RE: Saranam Golf Course & Montano
4701 Montano Rd NW
Grading and Drainage Plan
Engineer's Stamp Date: 2/15/2022
Hydrology File: E11D013B

Based upon the information provided in your submittal received 2/16/2022, the Grading & Drainage Plan **is not** approved for Building Permit. The following comments need to be addressed for approval of the above referenced project:

**RE: Saranam Golf Course & Montano
4701 Montano Rd NW
Grading and Drainage Plan
Engineer's Stamp Date: 1/4/2022
Hydrology File: E11D013B**

**RE: Saranam Golf Course & Montano
4701 Montano Rd NW
Grading and Drainage Plan**

SARANAM AT 4701 MONTANO RD NW		DRAWN BY LN
CONCEPTIONAL GRADING & DRAINAGE PLAN		DATE 10/20/2021
TERRA WEST, LLC 5571 MIDWAY PARK PLACE NE ALBUQUERQUE, NM 87109 (505) 858-3100 www.tierrawestllc.com		2019080_BASIN
		SHEET # C2.1
		JOB # 2019080

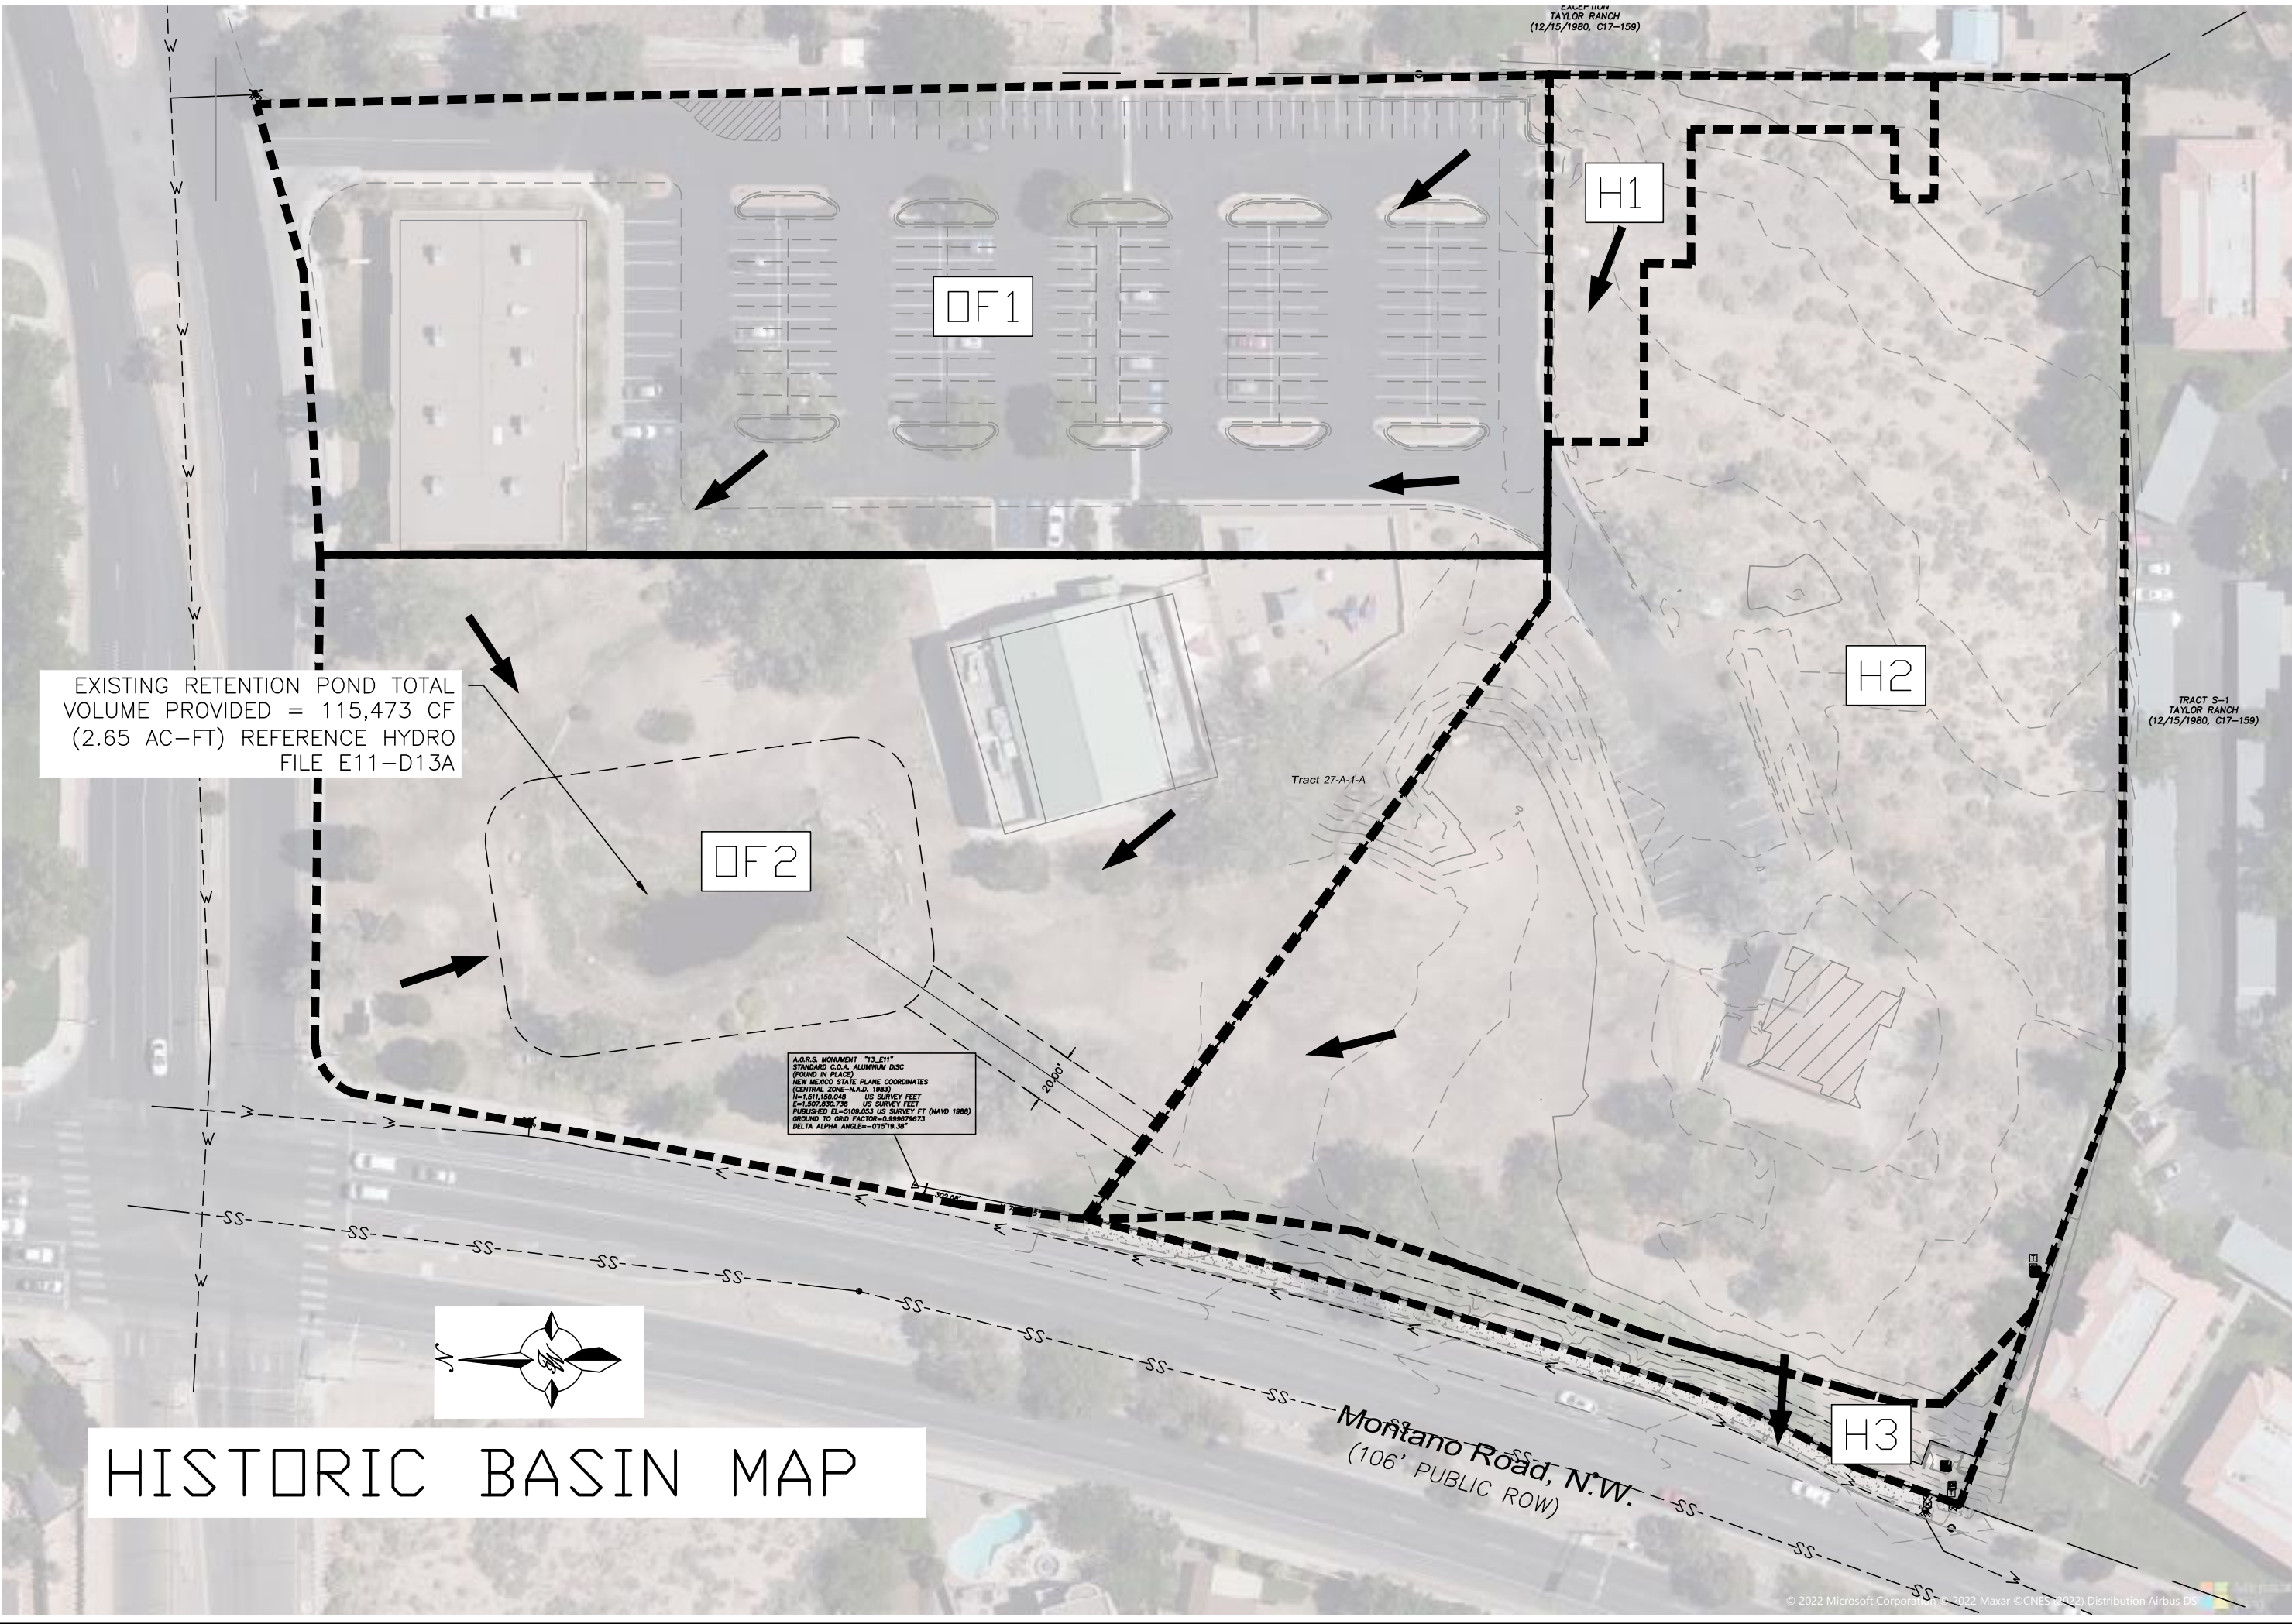
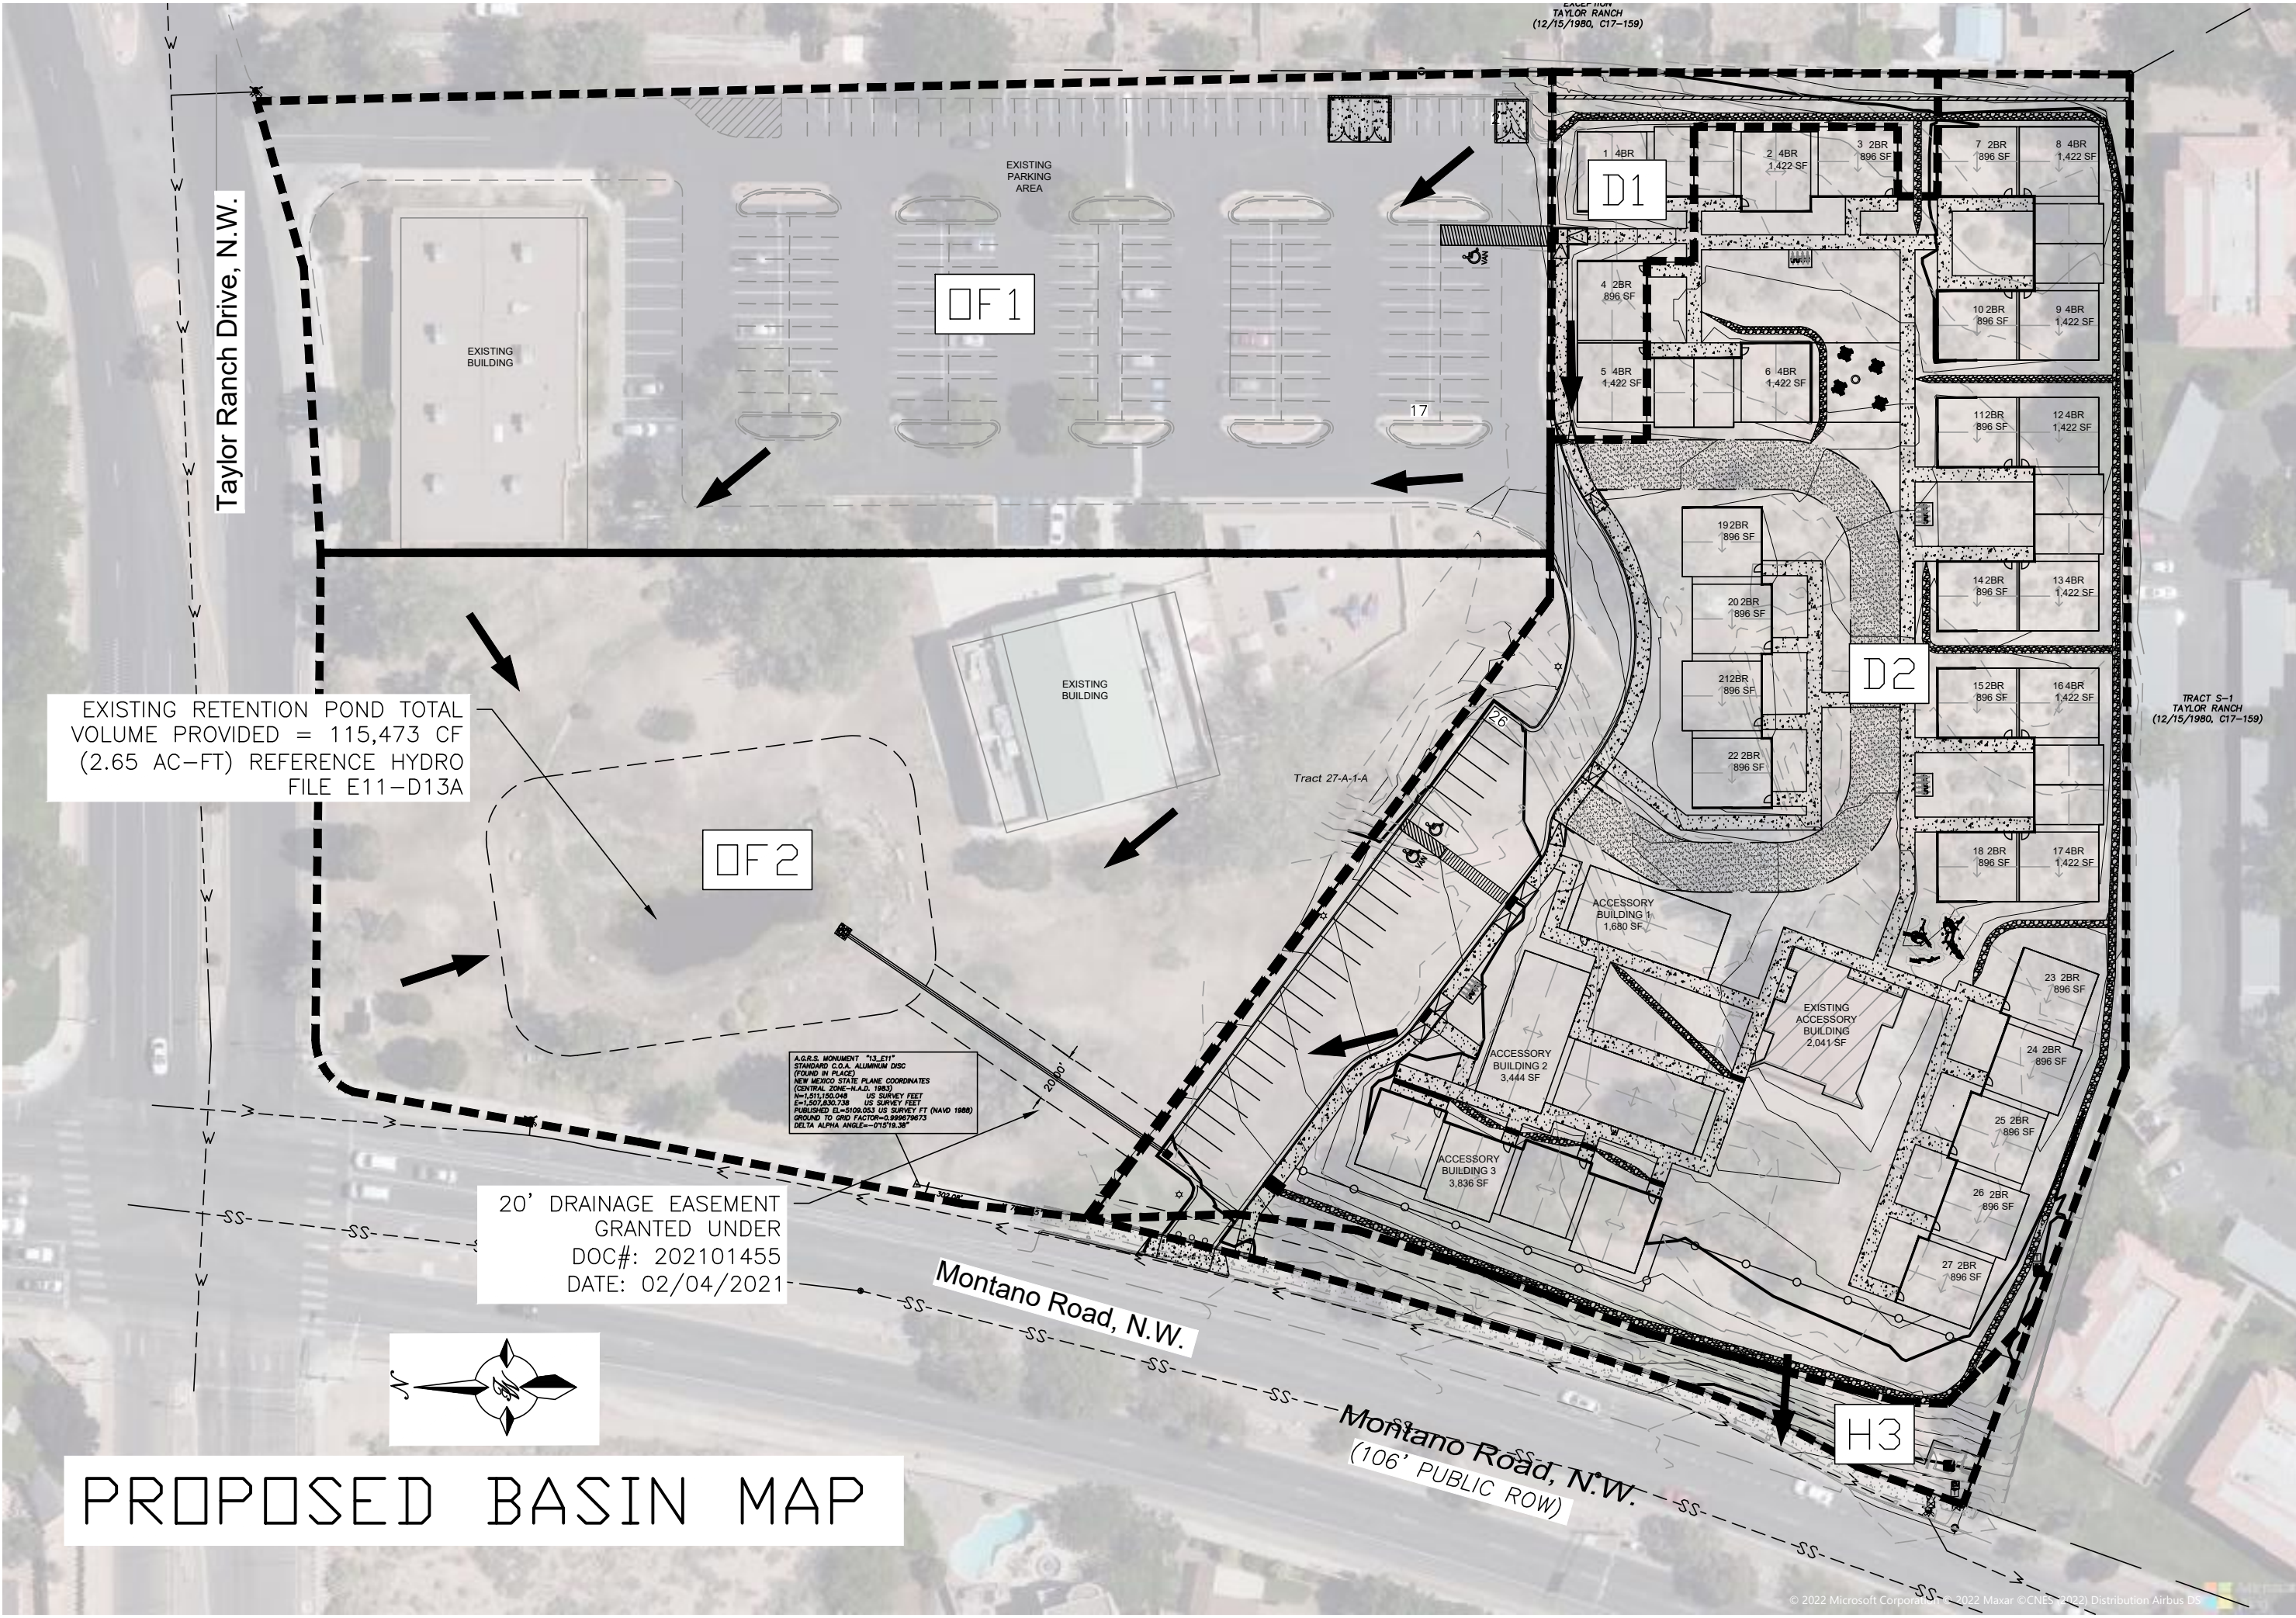
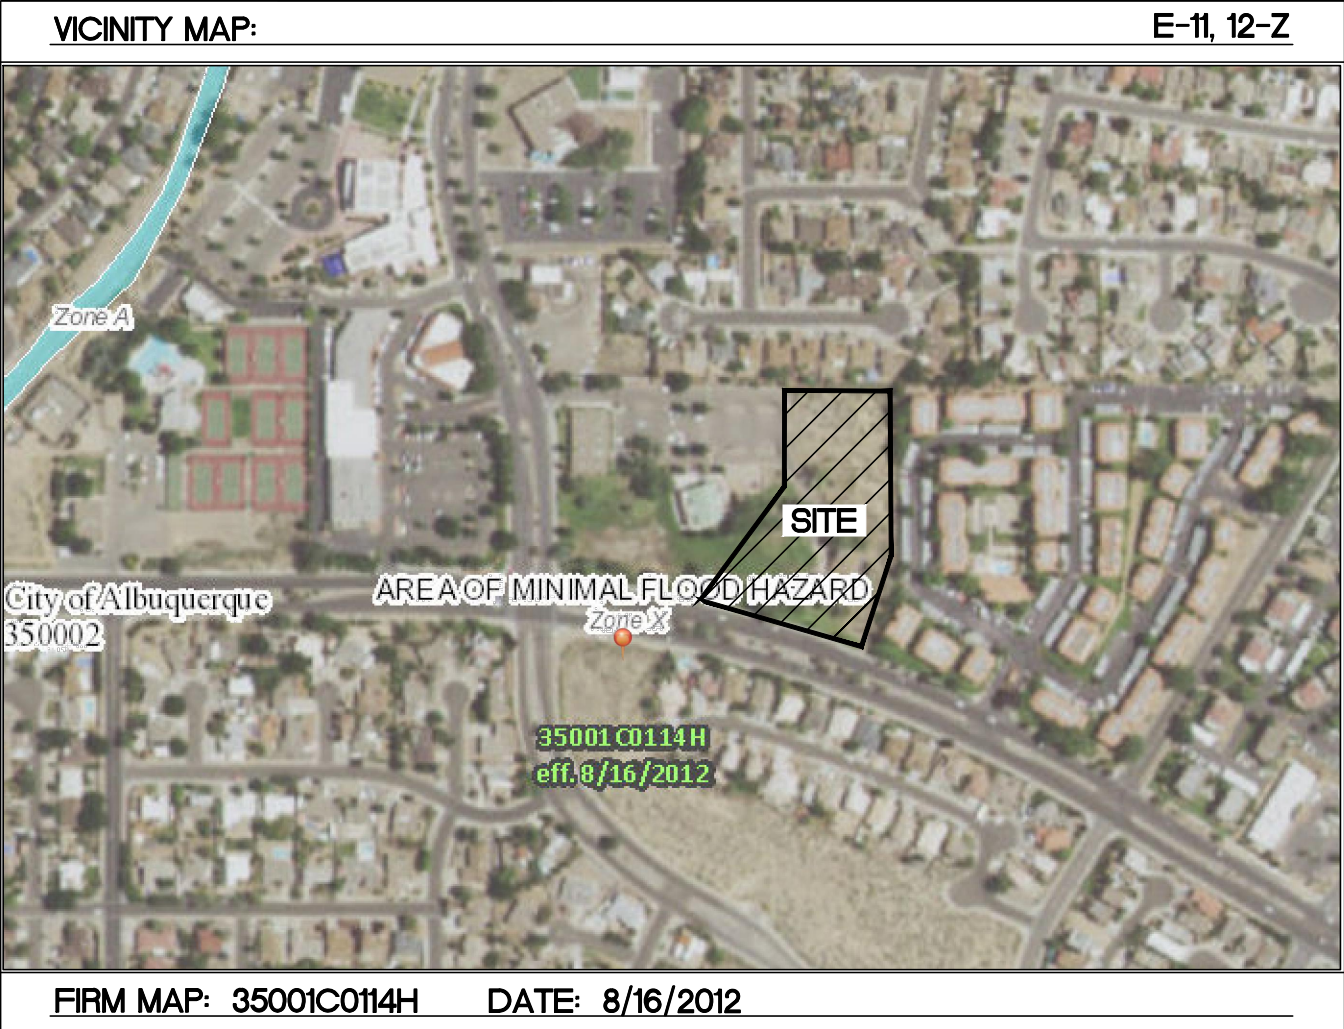
1. Please double check the calculations for the tables provided. I checked a couple and did not come up with the same.
2. Please include the required volume for retention. (100-year, 10-day storm)

Response: Calculations updated to new DPM chapter 6 requirements.

2. Please include the required volume for retention. (100-year, 10-day storm)
Response: Required volume included in sheet C2.1.
